ADDENDUM No. 1

Project Name:	Owner: City of Dexter Project Name: Dexter City Hall Renovations	Addendum No: One (1)
Project Number:	21-113	Issue Date: January 21, 2022
Project Location:	3515 Broad St. Dexter, Michigan 48130

SHEET NO.
A3-02

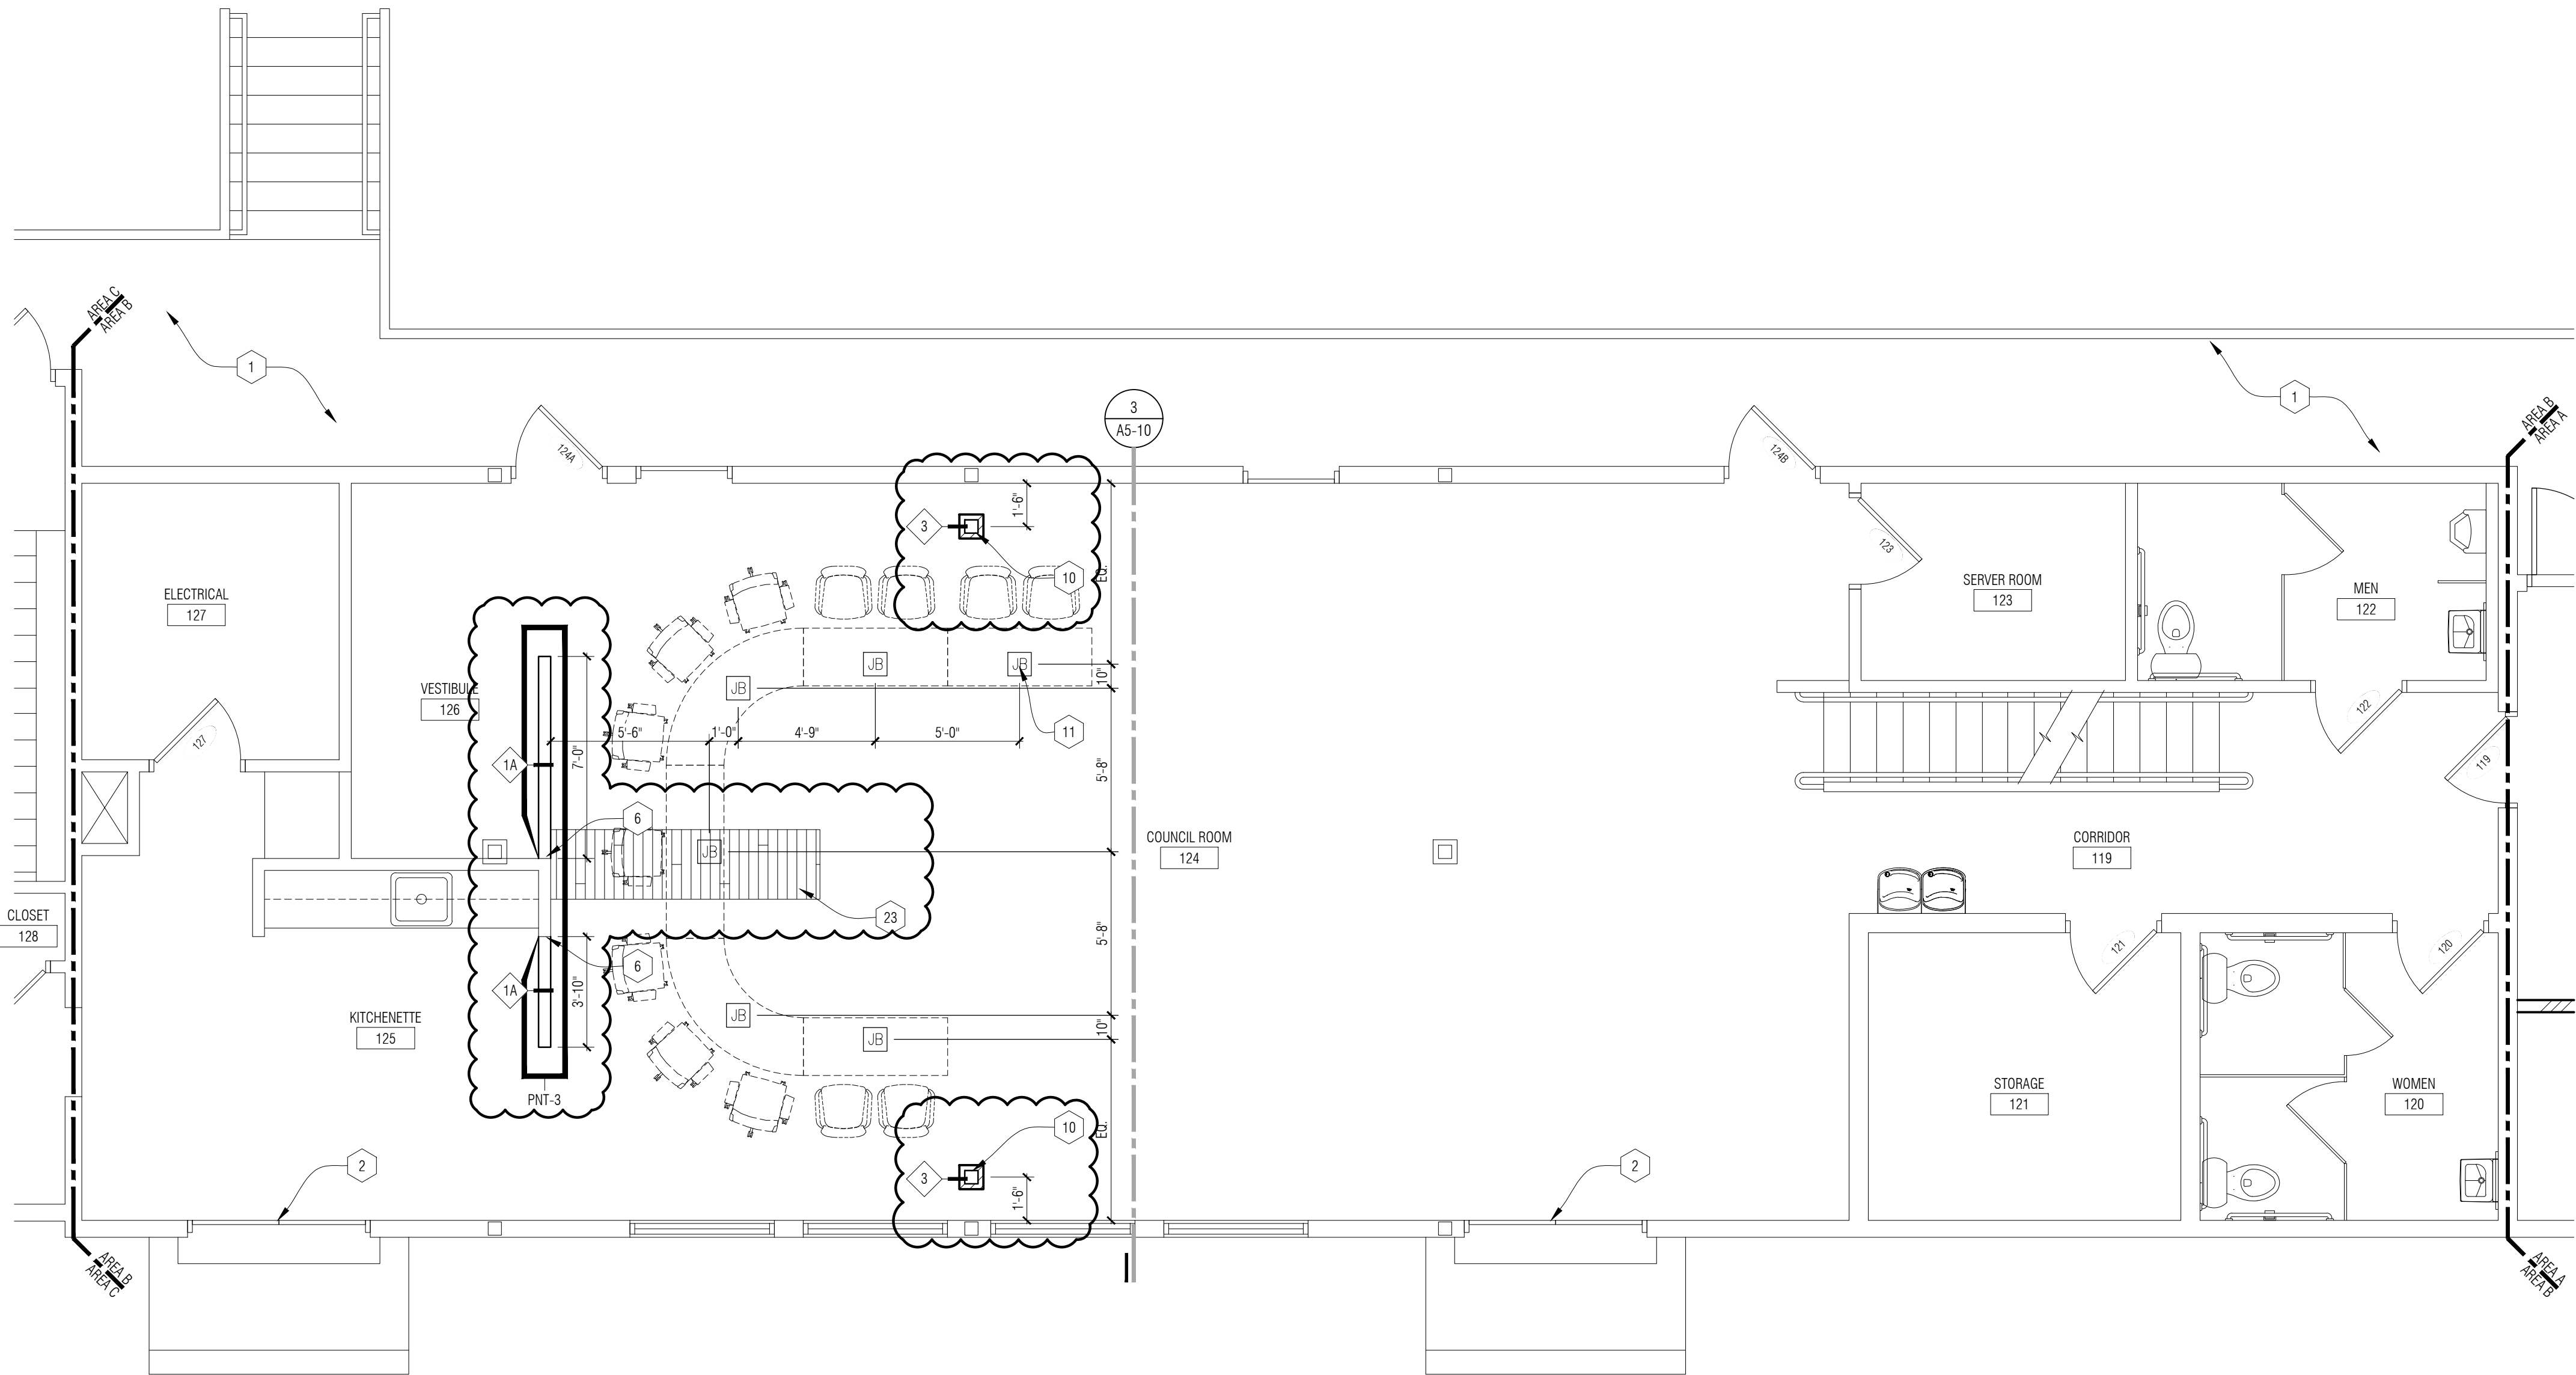
A. Added sump in elevator pit and associated keynote.
- ITEM A11** A3-02 1st Floor Plan – Area A (Revised & Re-Issued)
A. Added general note referring to A0-04 for floor transition details.

- B. Adjusted location of wall at Hoteling 103 to align with the south side of the new beam.
- C. Increased width of wall between service desk and door 109 to align with other walls in the area.
- D. Removed "V.I.F." from 5'-0" dimension at west end of Corridor 110.
- E. Identified which ACCU's at exterior were existing, and relocated. Added associated keynotes 17 & 18.
- F. Flipped door 104 and sidelight to ADA requirements.
- G. Updated keynote 14 to indicate supported slab, and to refer to structural details.
- H. Added note at existing walk to label as pitched to existing drains, and associated keynote 19.
- I. Added floor finish callout between new and existing wood floors, near elevator.
- J. Added interior elevation for Conference Room 104.

A3-04

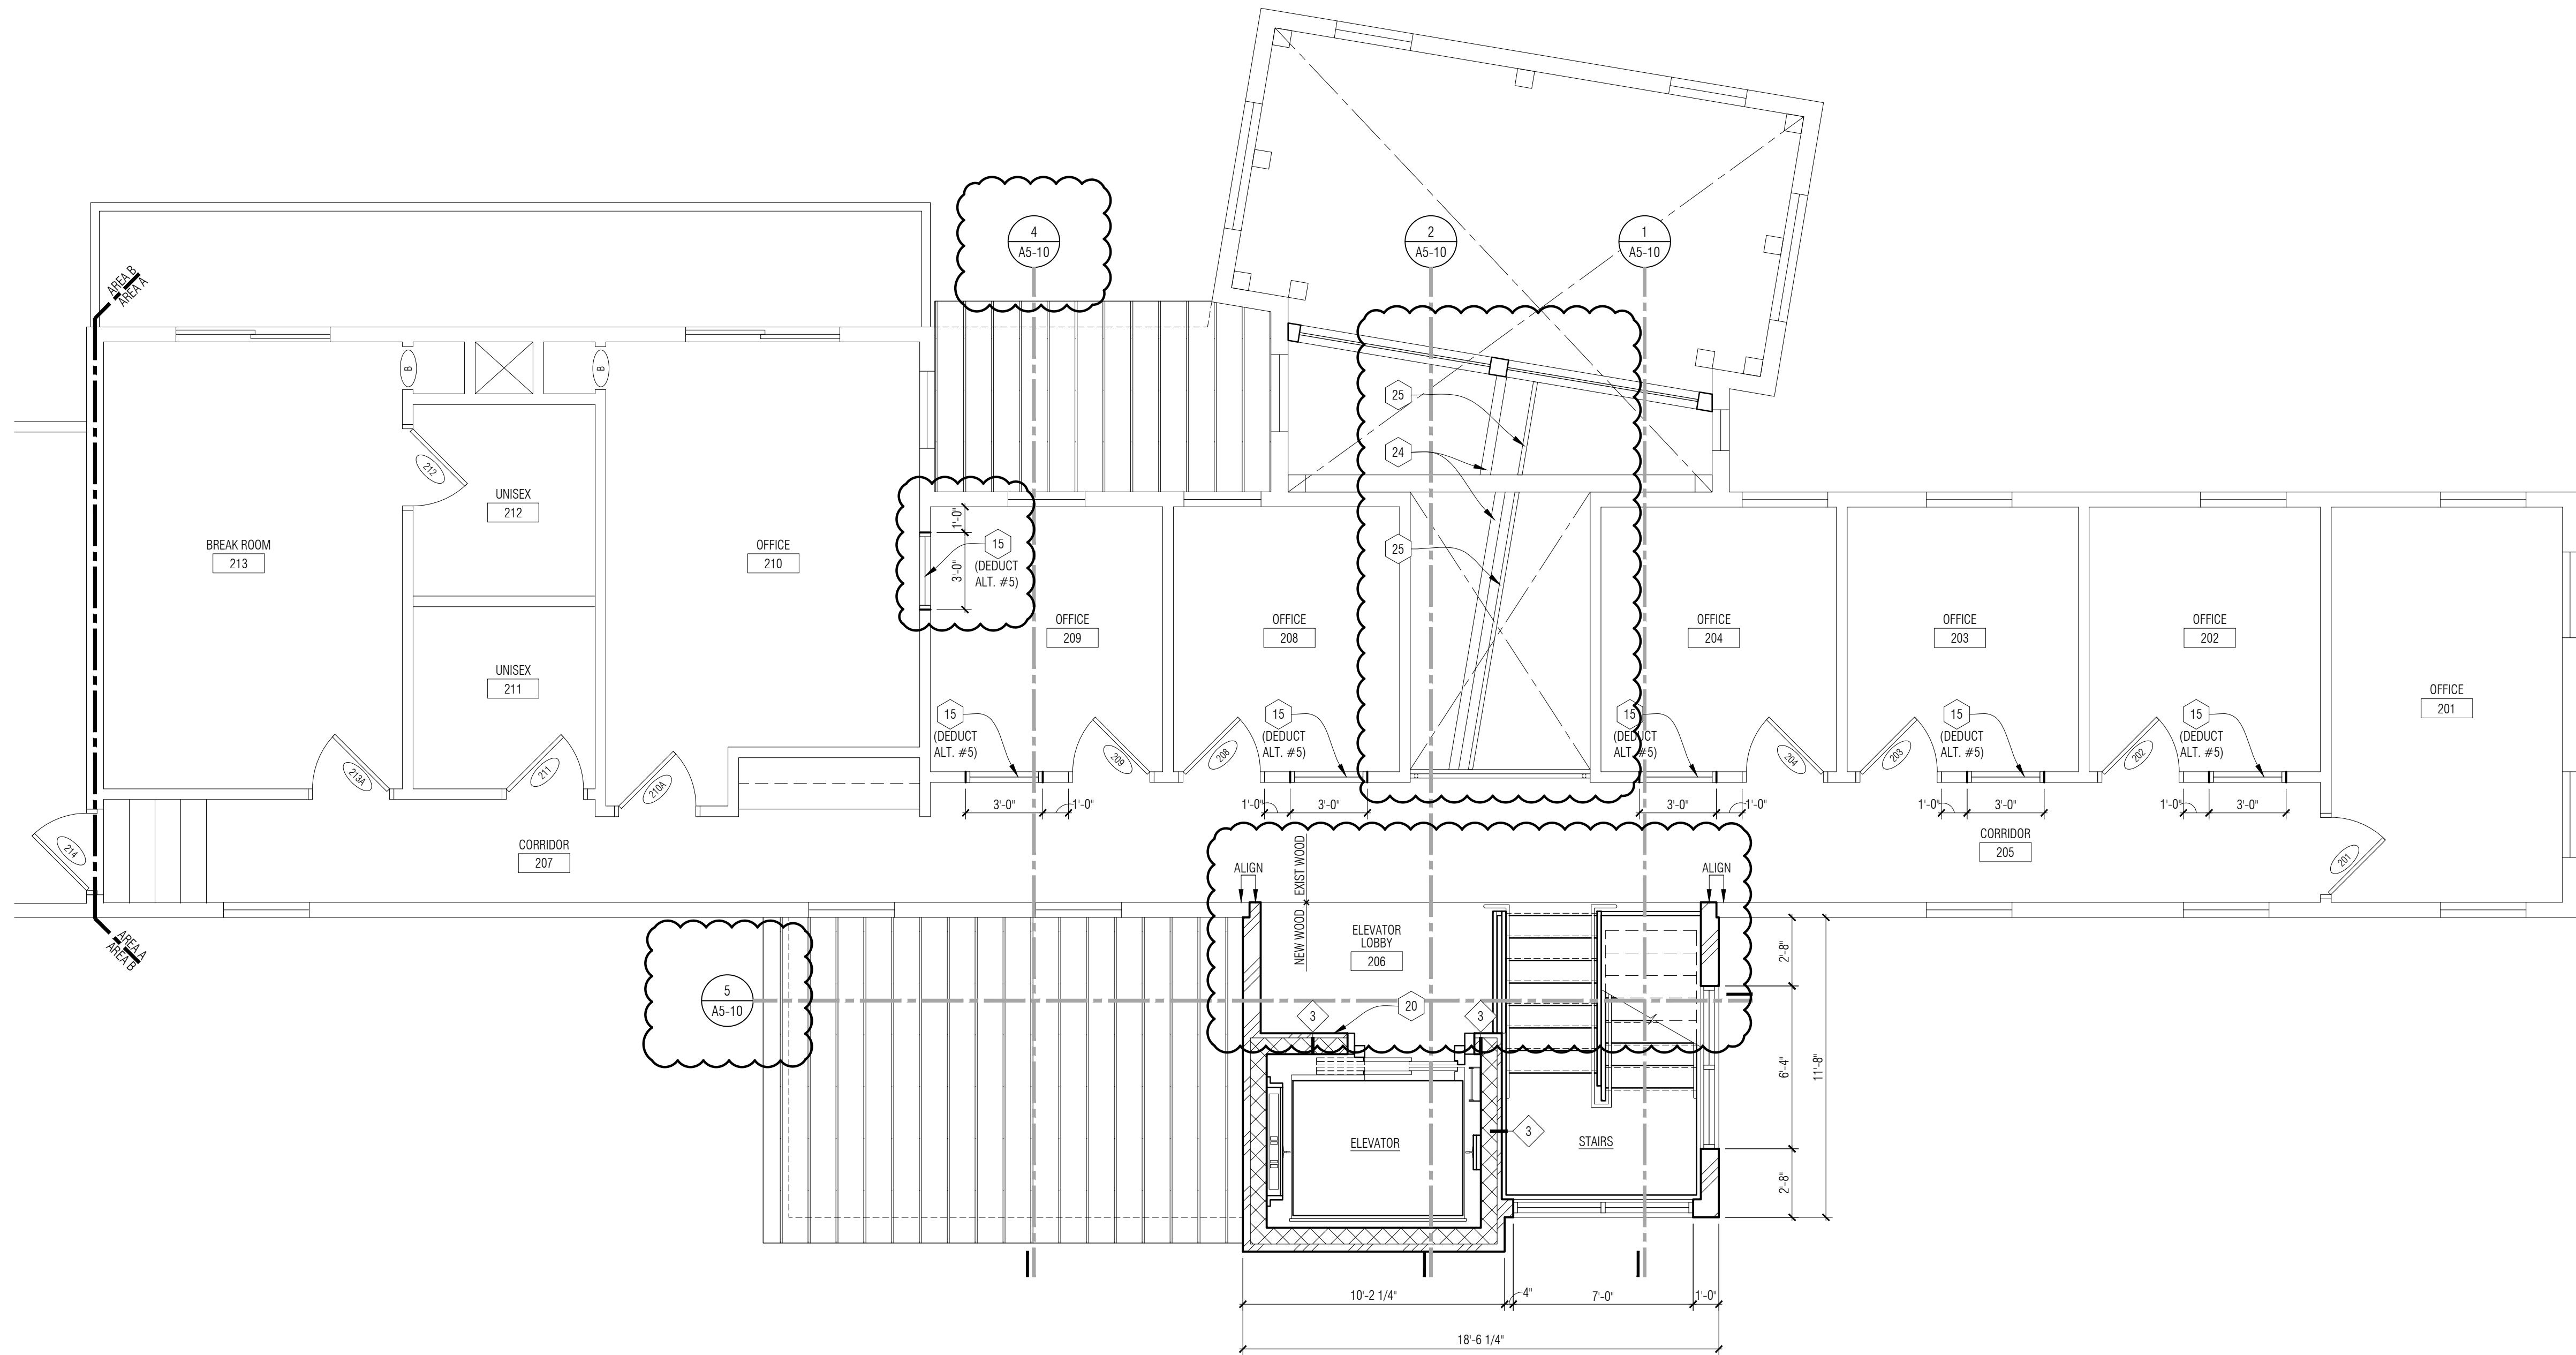
- A. Removed handrail at landing and replace with two risers.
